MIXED USE AFFORDABLE HOUSING 1950 Blanshard Street, Victoria, BC

D E V E L O P M E N T P E R M I T | J A N U A R Y 2 0 1 4
(REVISED JUNE 2014)

**VICTORIA ADVISORY DESIGN PANEL
MEETING NOTES OF May 28, 2014
COMMITTEE ROOM #1**

1950 Blanshard Street Development Permit Application #000336

SOUTH ELEVATION 1:100

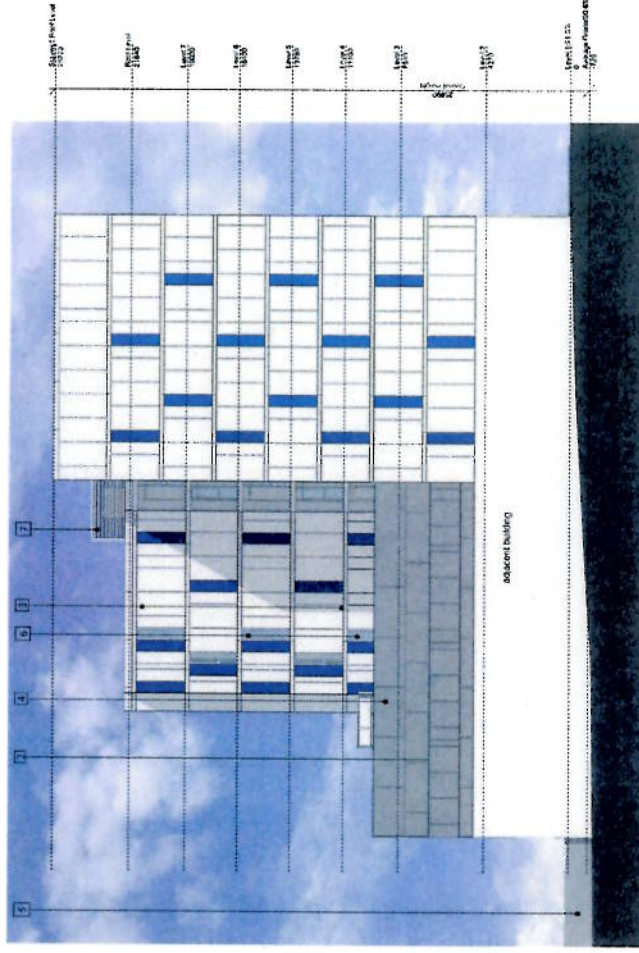
- The DCAP building separation guidelines recommend a setback above the podium level of three metres. The south elevation of the proposed building is on the property line. This zero setback could affect future development of the neighbouring property to the south and it raises Building Code issues related to window openings on a zero lot line. Setting back residential portions of this elevation above the second floor should be considered. In addition, the office windows on the second floor should be reconsidered.

- While the large massing of the south elevation is visually broken up with panel cladding and the use of colour, further measures to reduce the apparent mass should be considered.

1. That Advisory Design Panel recommend to Council that Development Permit Application #000336 for 1950 Blanshard Street be approved and that the applicant continue to work with staff to address the following issues:
 - Reconsideration of the provision of outdoor amenity space for residents via a roof top patio and individual patios for units on the second floor.
 - Reconsideration of the size and scale of operable windows for residential units.
 - Ensure the submission of a landscape plan, prepared by a registered landscape architect, is included in the plans presented to Council.
 - Review opportunities to differentiate the stair towers and/or podium from the overall building mass.
 - Reconsideration of the zero lot line configuration of the south building face to provide an increase setback for a portion of that façade.

- No change in the setback is proposed due to the uncertain timeframe of potential development to the south. In addition, the proposed windows animate the south elevation and Building Code issues can be addressed through water curtain or shutters. However, to break up the massing of the south elevation a vertical line of glazing at the end of the hallway is to be recessed.
- A further refinement of the building's architectural expression is proposed with respect to its top as well as with regard to the inflection of Blanshard Street.
- Further renderings of the pedestrian and vehicle driver experience of the building will be provided.

SOUTH ELEVATION 1:100

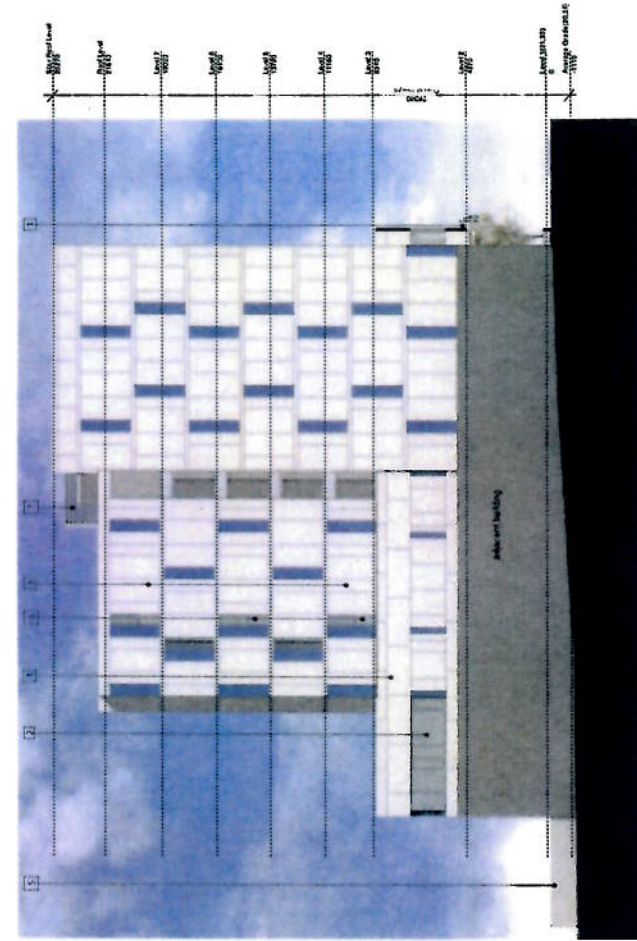
- The site is within Development Permit Area 7A which permits Council to regulate building design and landscaping.
- The location of the residential tower adjacent to the south property line does not meet the building separation guidelines in the *Downtown Core Area Plan*. The proposal would benefit from a review by the Advisory Design Panel.

The location of the residential tower on the south property line does not meet the building separation guidelines in the *Downtown Core Area Plan*. The proposal would benefit from a review of the south elevation as well as other aspects of design by the Advisory Design Panel.
